PROPOSED TECHNICAL SPECIFICATION

RELOAD 4/CYCLE 5

POWER AUTHORITY OF THE STATE OF NEW YORK  
JAMES A. FITZPATRICK NUCLEAR POWER PLANT  
DOCKET NO. 50-333  
DPR-59

SAFETY EVALUATION

Figure 3.1-2

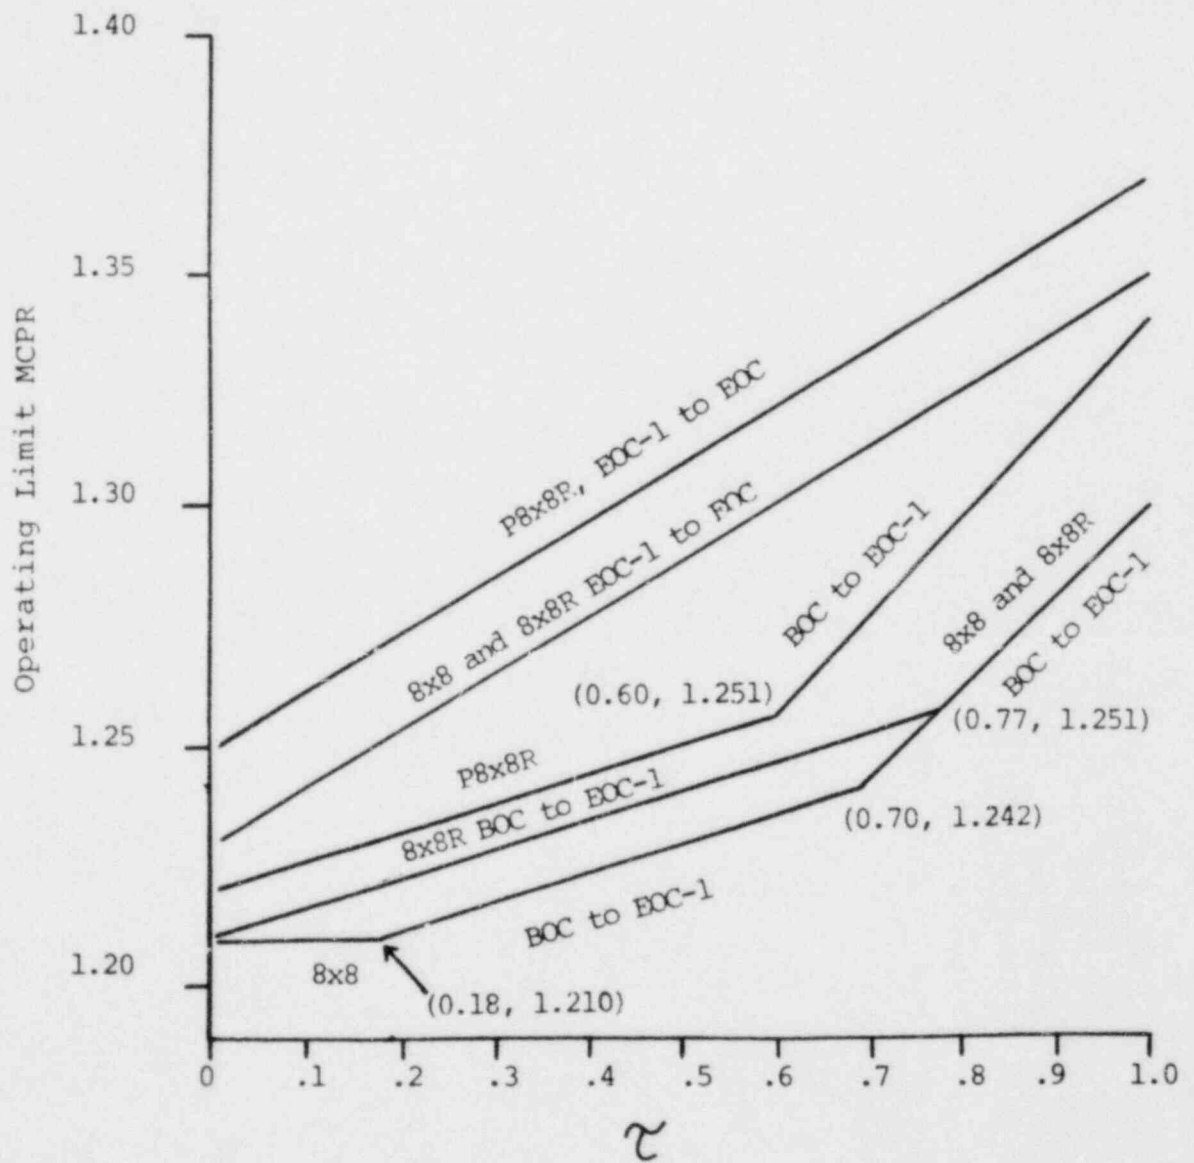
2. If requirement 4.1.E.1 is not met (i.e.  $\tau_B < \tau_{AVE}$ ) then the Operating Limit MCPR values (as a function of  $\tau$ ) are as given in Figure 3.1-2 \*

Section 3.1.B containing Operating Limit MCPRs has been rewritten; Specification 4.1.E concerning control rod and scram time test surveillance has been added and the Bases, (Sections 2.1 and 4.3.C) have been amended as a result of the use of the ODYN computer program (in lieu of REDY) to calculate the plant response to pressurization transients.

These changes are required to reflect the use of the ODDYN computer program for pressurization transient analysis. The new surveillance requirement on control rod scram times allows the use of ODDYN option "B" MCPR limits which are less restrictive than the deterministic option "A" limits.

issued under a letter [Reference (h)] dated January 29, 1981 detailed implementation procedures of the ODYN code. The changes made to Section 3.1.B are in accordance with the generic statistical adjustment factor approach (generally known as ODYN option "B") given in the supplementary safety evaluation attached to the January 29th letter. This generic statistical implementation method requires a new surveillance requirement on control rod scram time of the type contained in the new Section 4.1.E. In this test, periodic control rod scram time test data is checked against the statistical scram time test data used in the ODYN calculation; if the surveillance test data shows that the scram time exceeds that used in the analysis an adjustment is made to the operating limit MCPR as described in the revised Section 3.1.B.

Fig 3.5-3

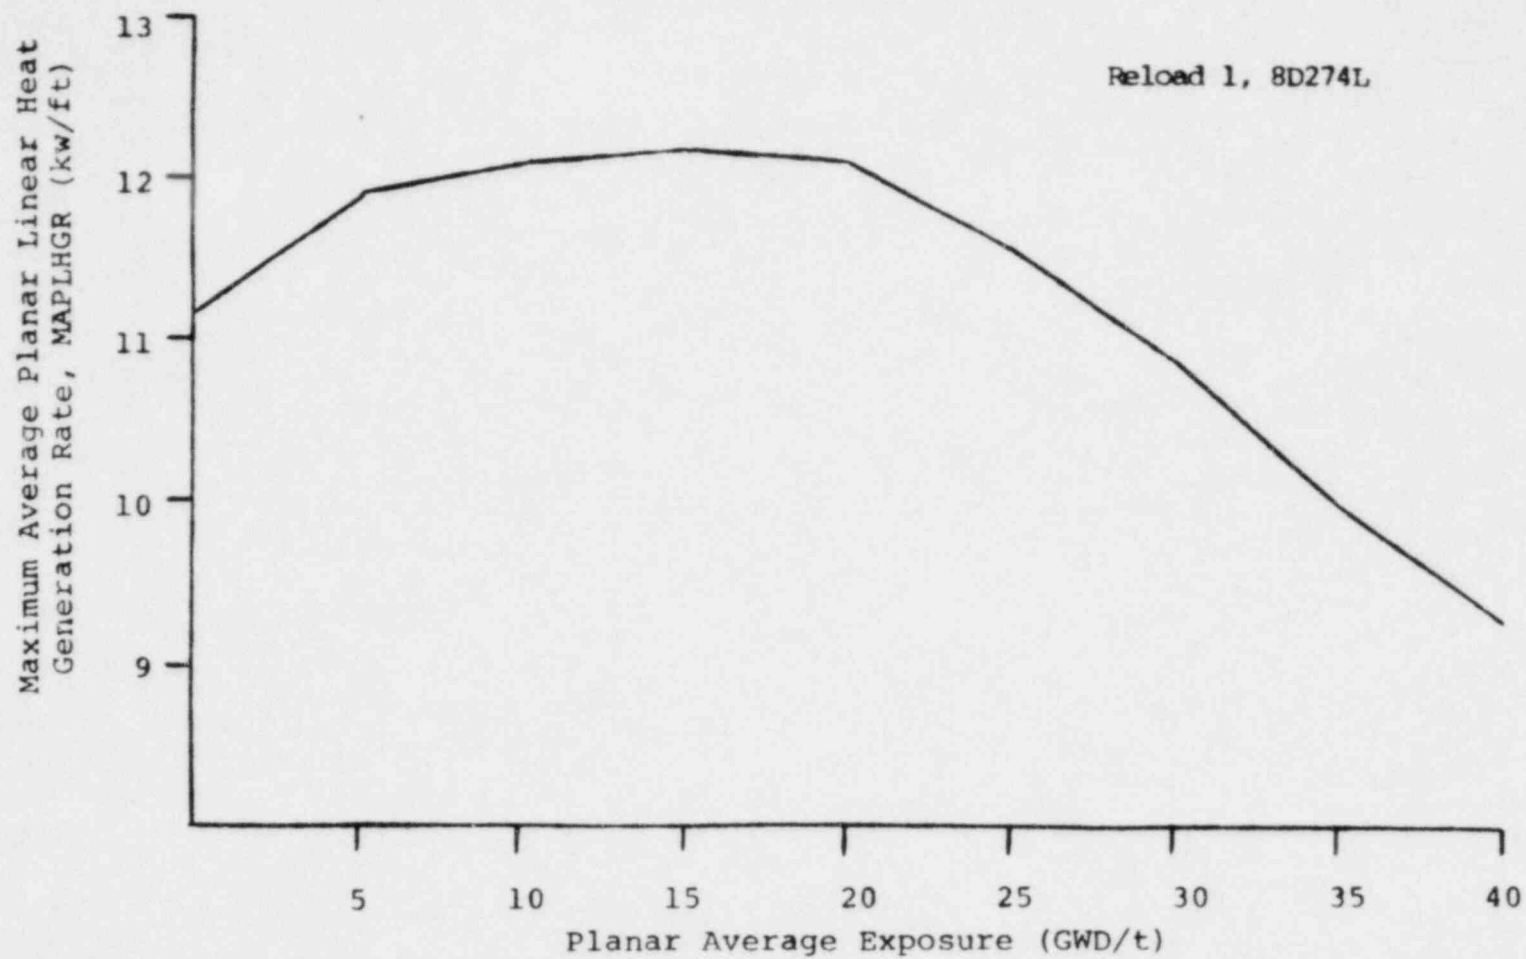
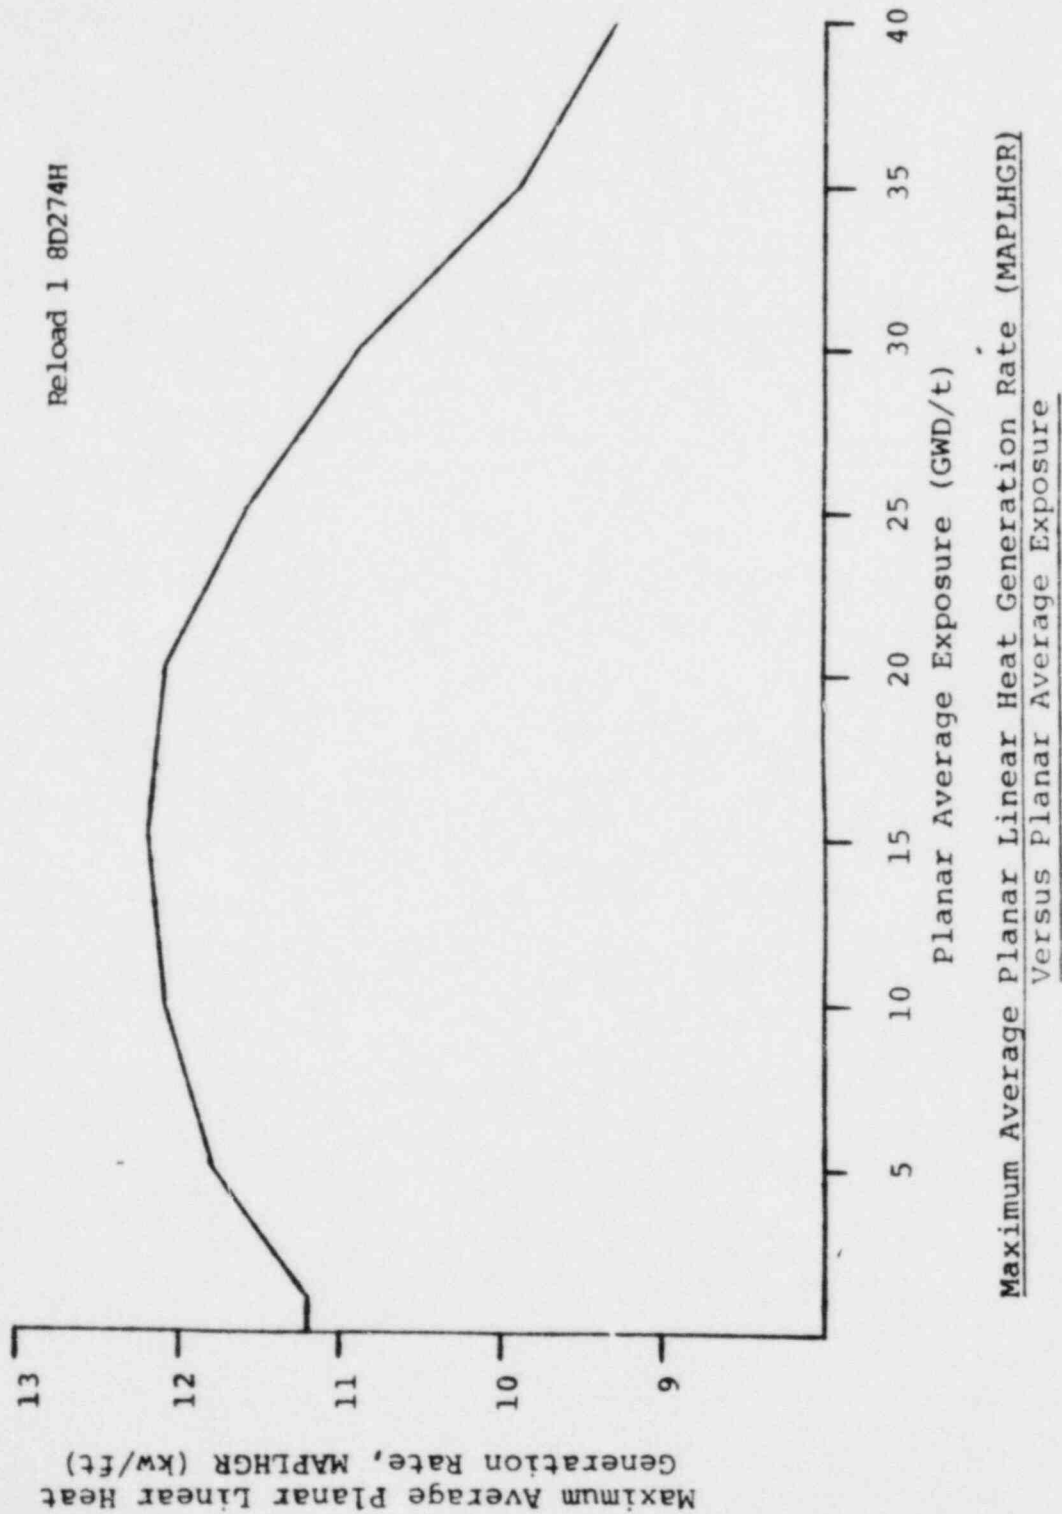
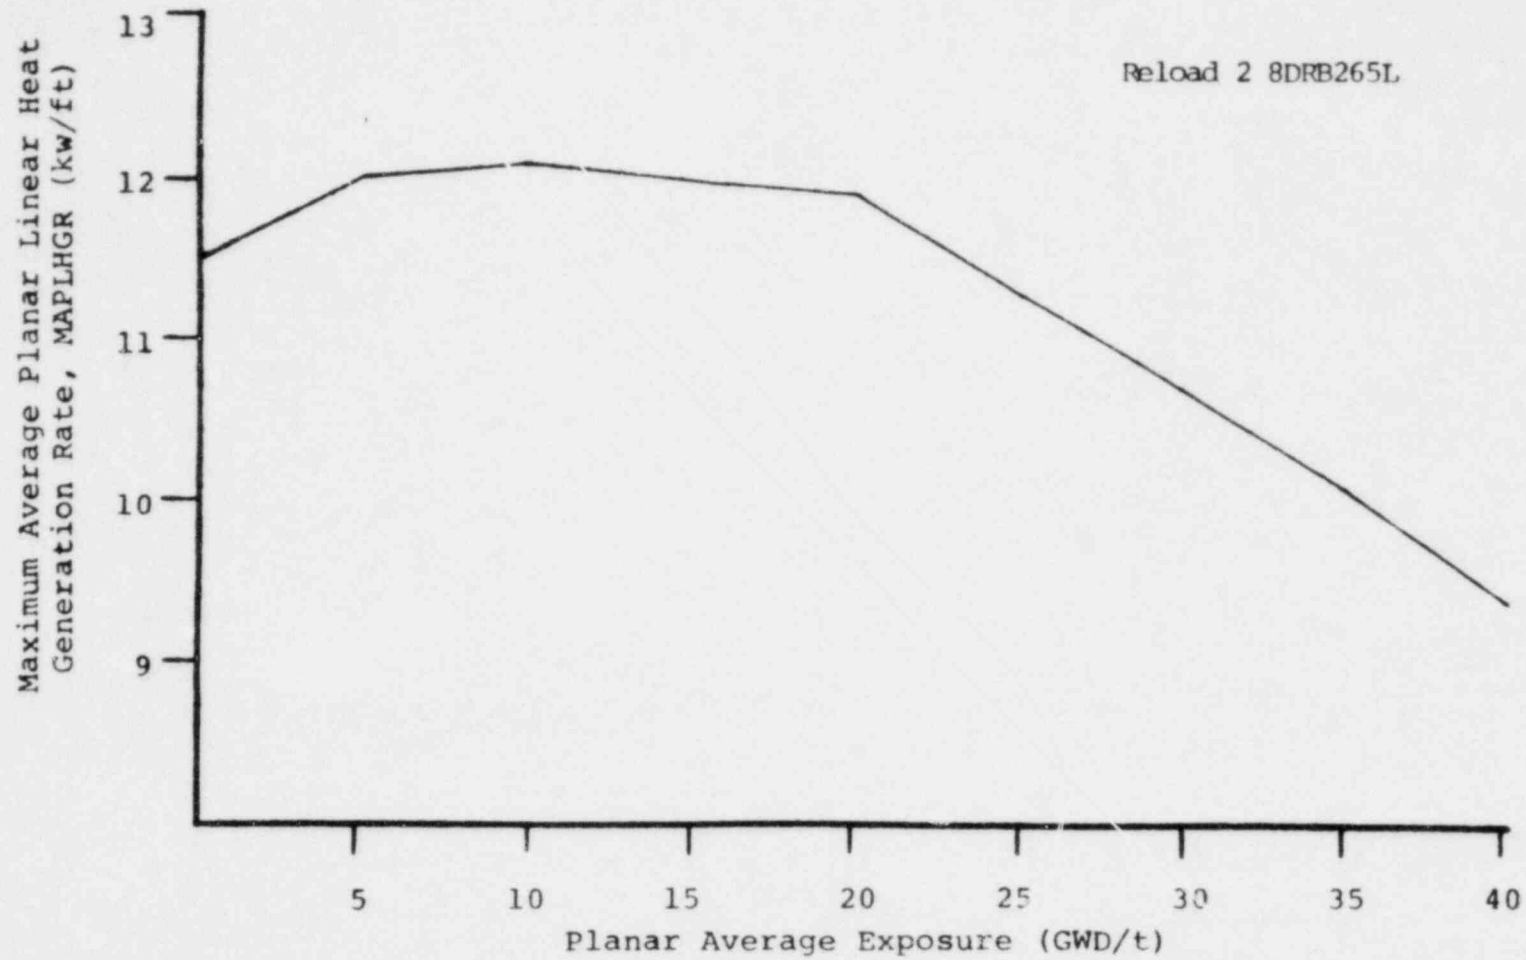
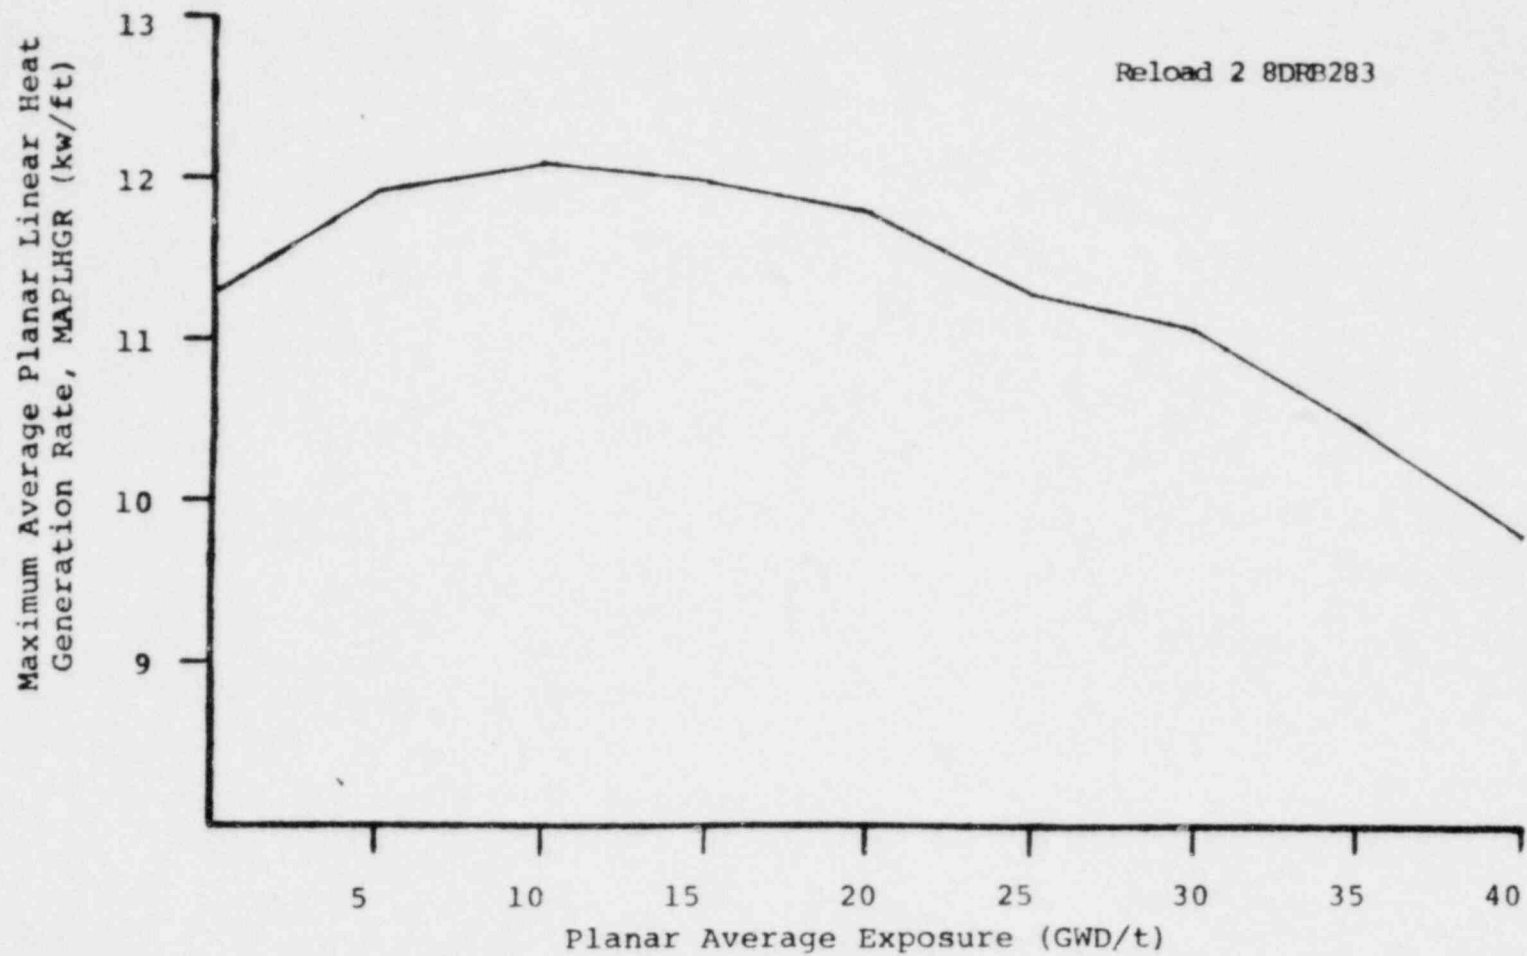
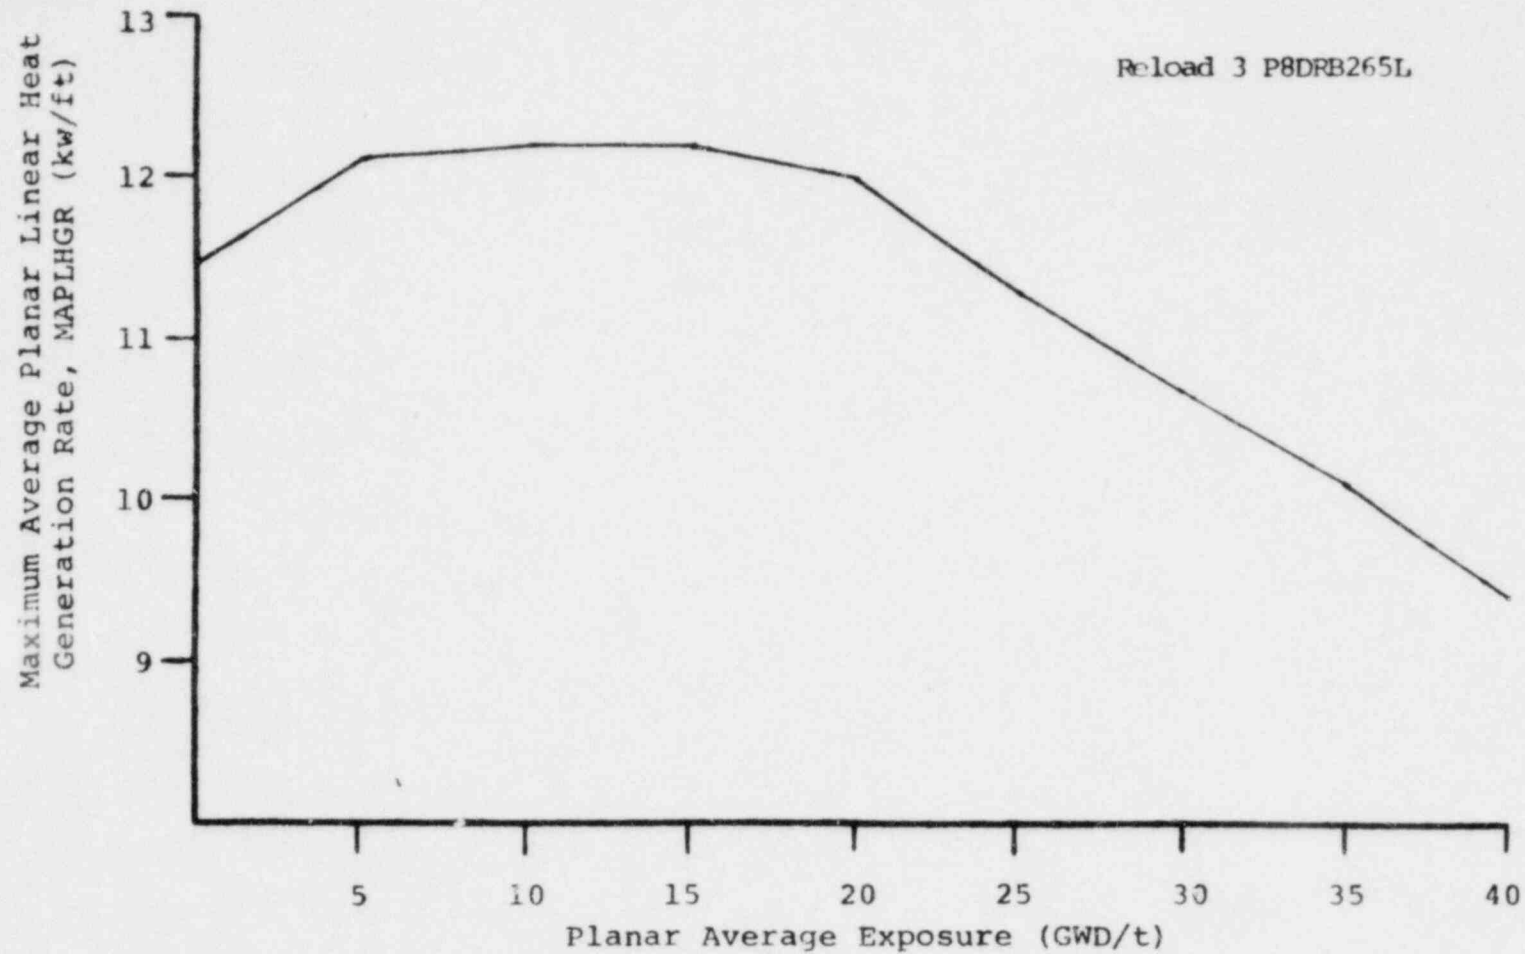
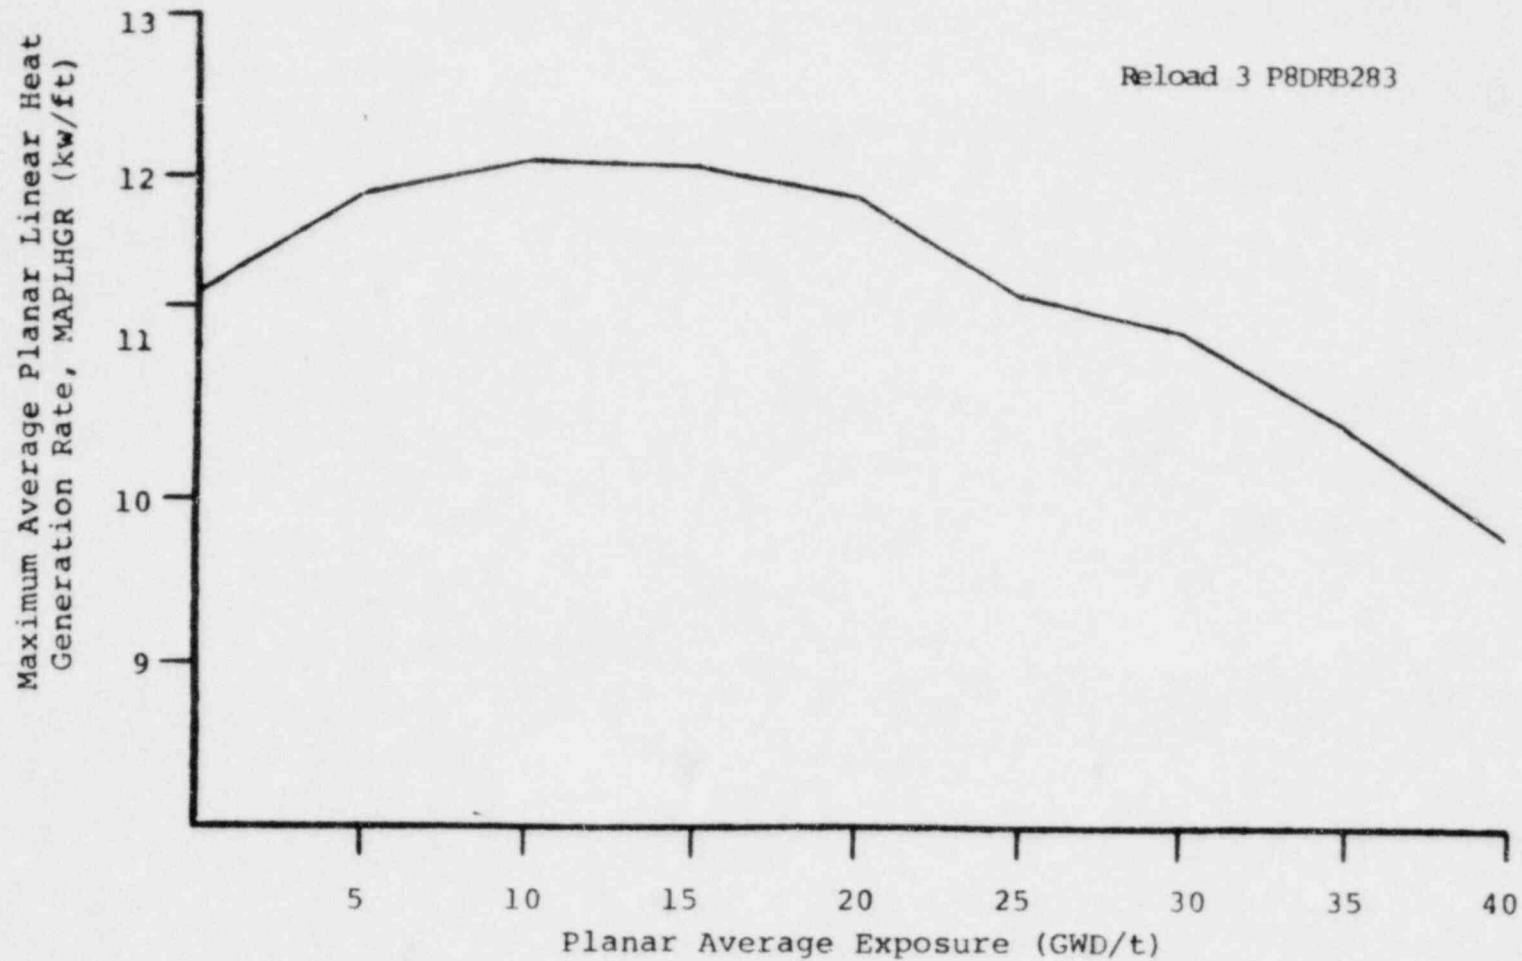
Maximum Average Planar Linear Heat Generation Rate (MAPLHGR) data for two new fuel types is provided in Figures 3.5-9 and 3.5-10. Additionally, the MAPLHGR data for all fuel types remaining in the JAF core (Figures 3.5-3 thru 3.5-8) has been extended from a maximum nodal exposure of 30 GWD/short ton to 40 GWD/short ton. This new MAPLHGR data was developed by General Electric as a revision to the General Electric Report NEDO-21662-2 (Attachment III).

The methods used to generate the new MAPLHGR limits are the same as those used in the original LOCA Analysis which was presented in NEDO-21662-2. The effect of enhanced fission gas release at high exposures on these extended MAPLHGR limits was discussed in a letter dated May 6, 1981 from R. E. Engel of General Electric to T. A. Ippolito. In this letter, General Electric demonstrates that adequate margin to the 2200<sup>o</sup>F peak clad temperature (PCT) limit exists when General Electric's evaluation of the fission gas correction factor is applied.

The MAPLHGR curves are being extended in anticipation of exceeding the present 30 GWD/short ton limit in Cycle 5. Based on current predictions of Cycle 5 energy content, the maximum cumulative nodal exposure at end of Cycle 5 will be approximately 36 GWD/short ton.

The extended MAPLHGR limits are an amendment to General Electric report NEDO-21662-2, "Loss-of-Coolant Accident Analysis Report for James A. FitzPatrick Nuclear Power Plant (Lead Plant)" which was submitted to the Commission in a letter from George T. Berry to Robert W. Reid, Chief of Operating Reactor Branch, on July 29, 1977 [Reference (d)]. This report forms the basis of the ECCS analysis for the FitzPatrick plant and SER issued by the Commission on September 16, 1977. Thus the proposed modifications will not alter the conclusions reached in the FSAR accident analysis and SER since they are based on the same plant response calculated in NEDO-21662-2 report and have been calculated using the same approach as the previous MAPLHGR.
